**Supplementary report**

**Planning Scheme Amendment C190 Arden-Macaulay**

**Council**

**30 August 2016**

Figure 8: DDO areas

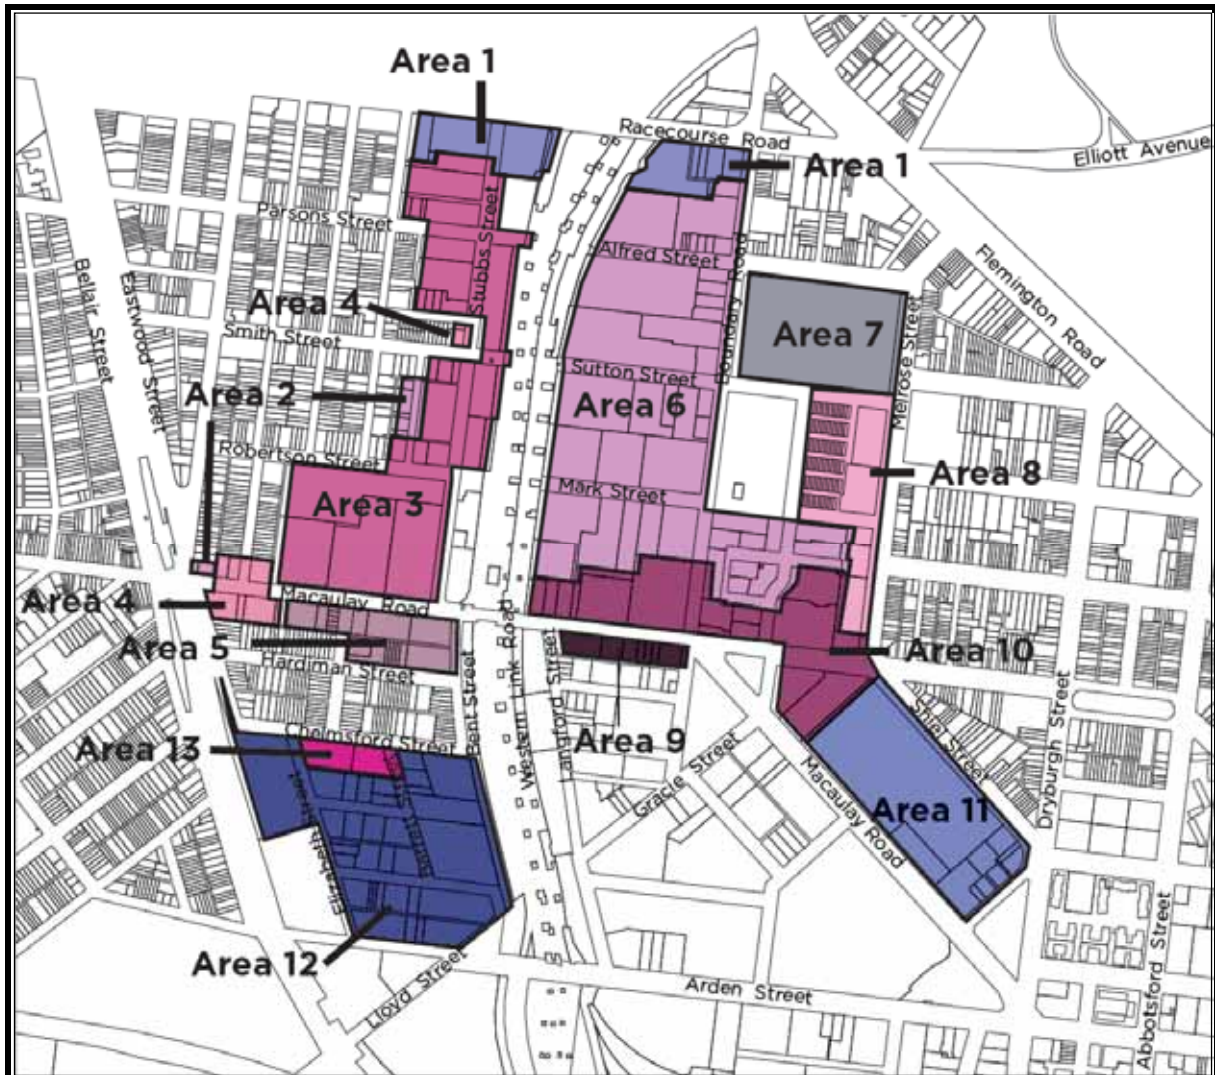
Mr Chamberlain on behalf of the owners of 89-96 Stubbs Street submitted that Thompson Street, which forms the western boundary of the site is not characterised by low-scale development. It is currently in the Industrial 3 Zone, but there is one existing dwelling opposite the site. It is a non-conforming land use. Mr Chamberlain submitted that the more stringent height and setback provisions set out in Figure 9 of DDO60 should not apply to this interface.

**PANEL'S RECOMMENDED DDO MAP1 STREET WALL HEIGHT AND SETBACKS**

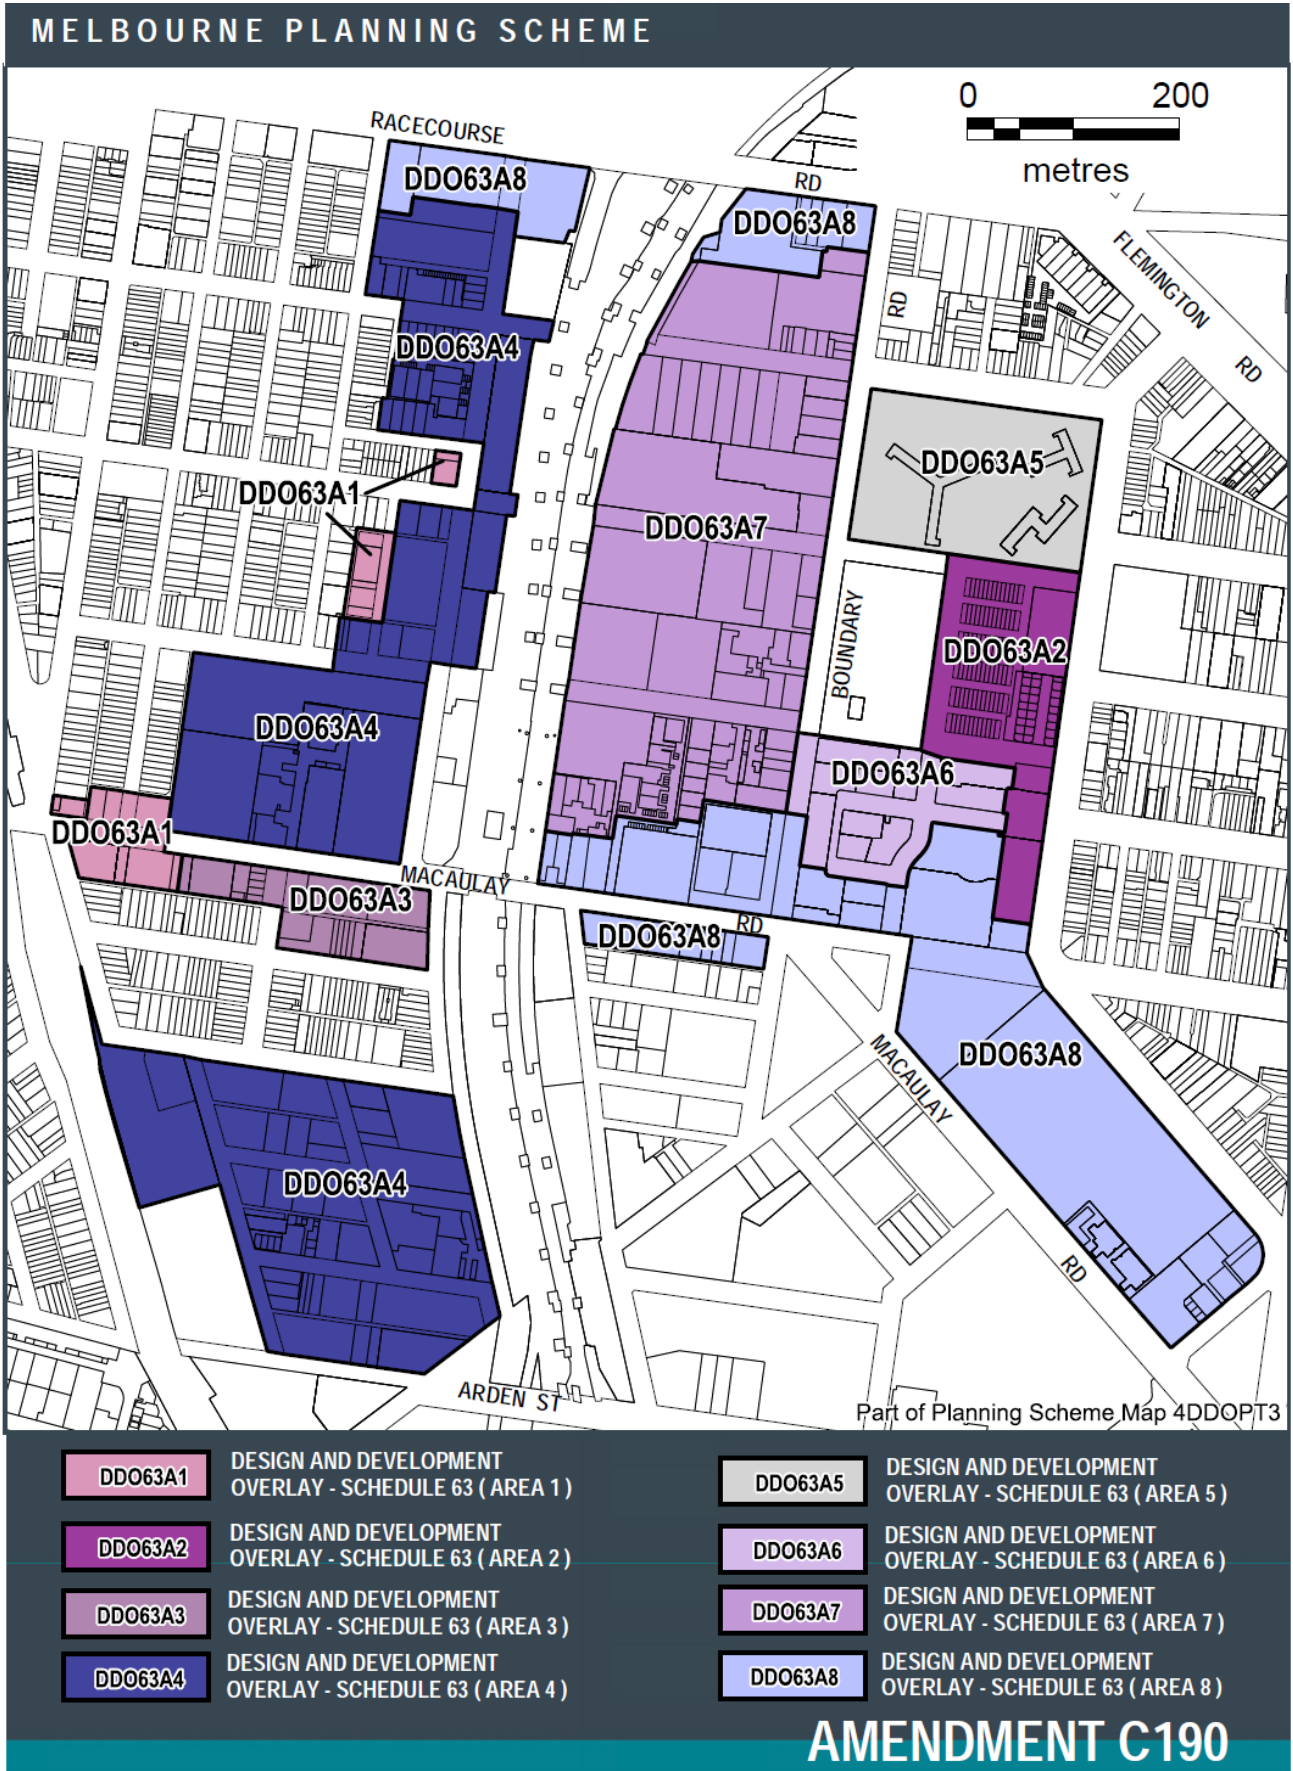
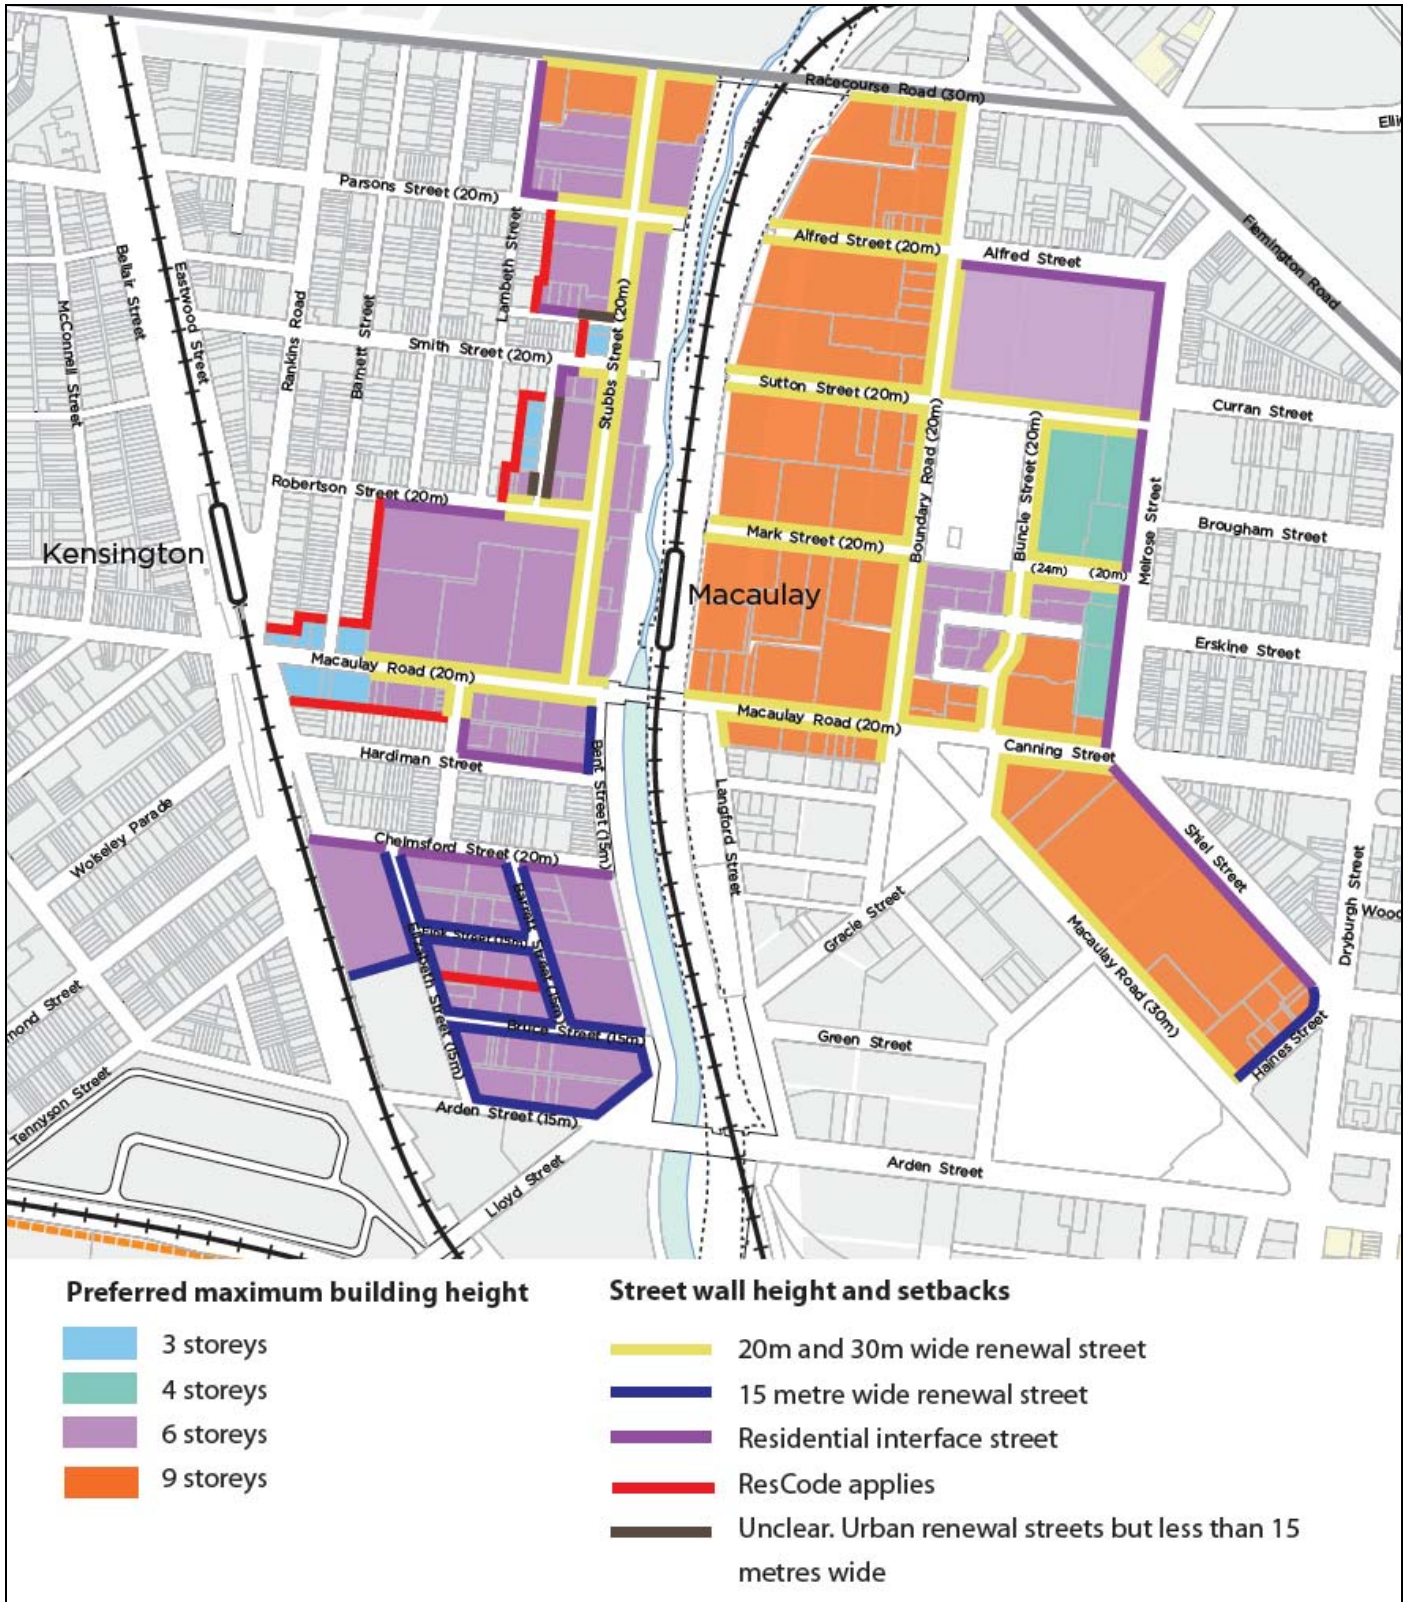
Update the weather protection and facade treatment as shown in Appendix C of the panel report.	Accept	The alternative wording better meets the overall aim of creating visually interesting streets fronted by well-designed buildings and provides a better, more flexible response to the façade articulation objective.
	<p>Delete the map of proposed laneways.</p> <p>And instead, specify:</p> <ul style="list-style-type: none"> <li>• Development must provide for a high quality pedestrian link generally along the eastern side of CityLink to provide direct pedestrian connection to Macaulay and Flemington Bridge Stations for land between Macaulay Road and Racecourse Road.</li> <li>• Development should provide for a fine-grained system of laneways and pedestrian connections that are: <ul style="list-style-type: none"> <li>- Safe, direct and attractive.</li> <li>- Publicly accessible.</li> <li>- Aligned with other lanes or pedestrian connections to provide direct through routes.</li> </ul> </li> </ul>	Accept in part	<p>The panel’s recommendation to remove the map of proposed new laneways and replace it with the suggested provisions is consistent with the recommendation from other recent panel hearings (eg. C171 Southbank and C196 City North). Council is doing further work on through block links to try to resolve this issue.</p> <p>Together with the removal of the map of proposed new laneways, the panel also recommended the removal of laneway controls along both proposed and existing laneways but did not explain why the street wall height and setback controls along existing laneways should be removed. Management does not support the removal of street wall height and set back controls on existing laneways. It is however recommended that the laneway controls (identified as figures 2 and 3 in the Council-endorsed post exhibition version) be translated into a more conventional expression of street wall height and set back as follows:</p> <p style="padding-left: 40px;">Development along the laneway must not exceed a height of 3 storeys.</p> <p style="padding-left: 40px;">Development above the street wall should be set back 4 metres. In addition, development on the northern side of an east-west laneway should be set back 1 metre for every metre of height above the preferred maximum height.</p> <p>Management also recommends adding a requirement under ‘Connectivity and laneways’ for new development along laneways and pedestrian connections to comply with the laneway street wall height and setback controls.</p>

Apply the 'ResCode Applies' interface requirement to the rear of residential properties in Bruce Street.	Accept	Even though they are not residentially zoned, there are a number of properties along this RoW which are used for residential purposes and their amenity should therefore be appropriate protected.
--	--	--------	--

**MANAGEMENT'S RECOMMENDED DDO MAP1 STREET WALL HEIGHT AND SETBACKS**
